Metering Task Force Conclusions and Manual 01 Revision

System Operations Subcommittee

September 28th, 2016

Manual 01, Revision 33

Fully Metered EDC Tie Lines

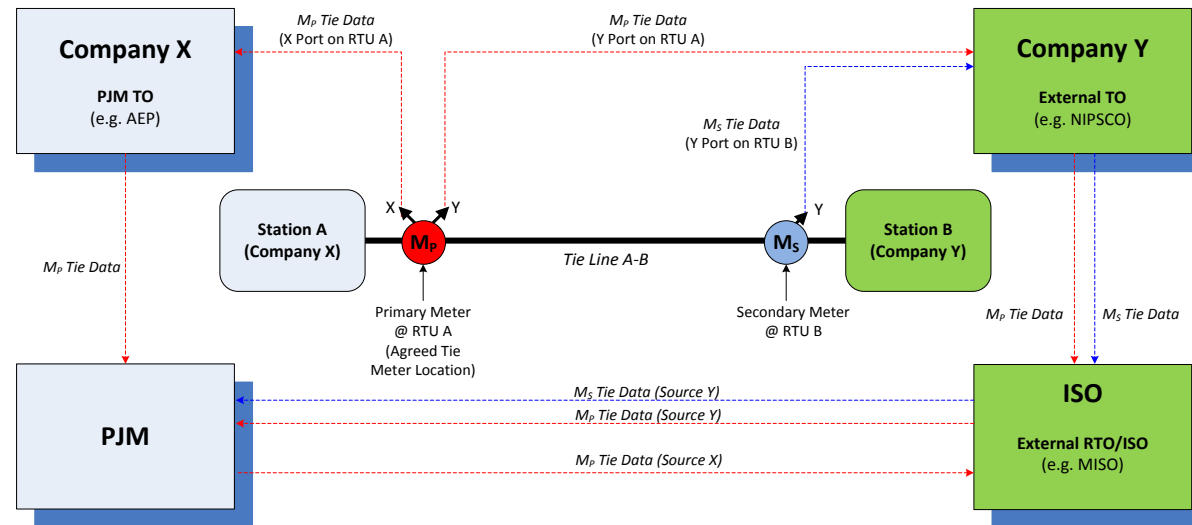
5.2.1.3 Internal Tie Lines

Control Zone Tie Lines

Transmission Zone Tie Lines

East EHV Tie Lines

5.2.1.3 Internal Tie Lines Transmission Zone, Fully Metered EDC, East EHV Tie Line Requirements

A primary meter is required.

Meter	Accuracy	Scan Freq.	Telemetry
Primary	+/- 2%	10 sec. or less between scans	The primary meter telemeters to the owning TO and other end TO. Both TOs telemeter to PJM.
